NAVIGATION - INSTALLATION OF DUAL LITEF HYBRID NAVIGATOR UNITS AND RNP AR = 0.3 SOFTWARE

MODEL	SERIAL NUMBERS
680 (Citation Sovereign+)	-0501 thru -0600

SB680-34-41
Page 1 of 8

Figure 1. Installation of the Dual Litef Hybrid Navigator Units and Configuration Modules (Sheet 1)

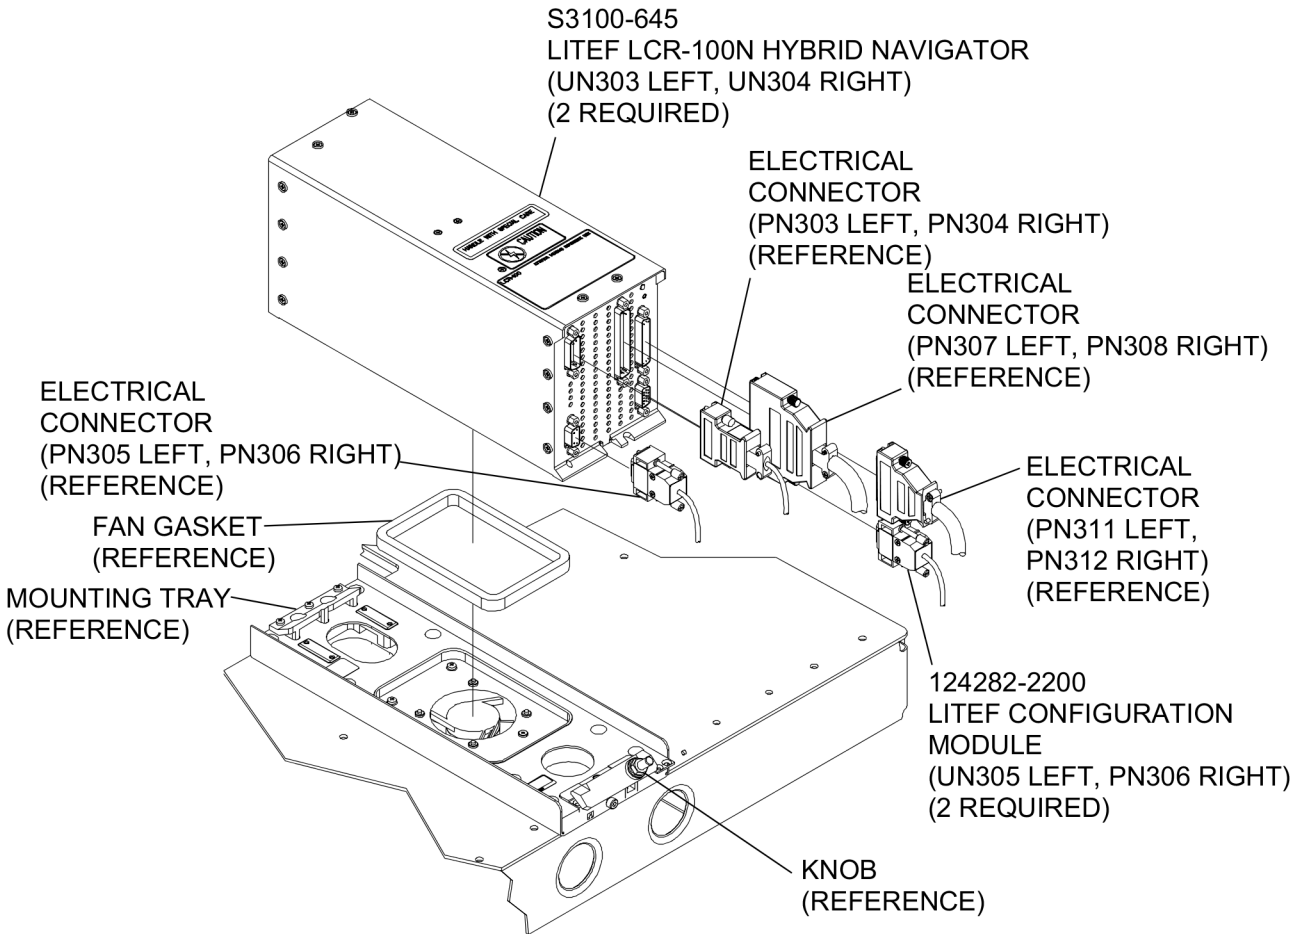
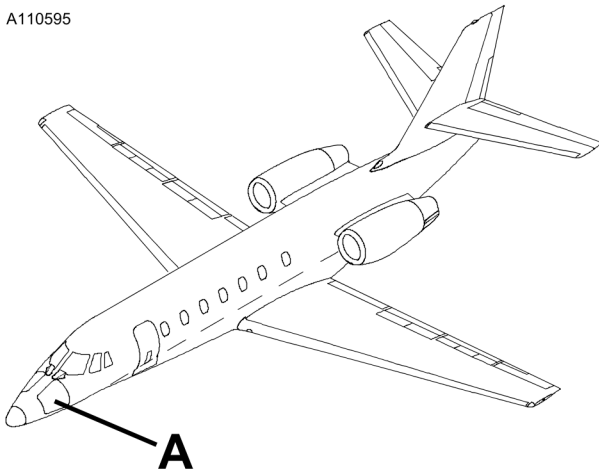
2. (Refer to Figure 1, Detail A.) Install Upgraded Dual Litef Hybrid Navigator Units as follows:
 - A. On aircraft with 145130-3000 LCR-100N Hybrid Navigator Units installed, do the steps that follow:

- C. Install two S3100-645 Litef LCR-100N Hybrid Navigator Units (UN303 left, UN304 right). (Refer to Cessna Model 680 Maintenance Manual, Chapter 34, Litef LCR-100N Hybrid Navigation System (HNS) - Maintenance Practices (Airplanes 0501 and ON)).

- E. Install two 124282-2200 Litef Configuration Modules (UN305 left, UN306 right). (Refer to Cessna Model 680 Maintenance Manual, Chapter 34, Litef LCR-100N Hybrid Navigation System (HNS) - Maintenance Practices (Airplanes 0501 and ON)).
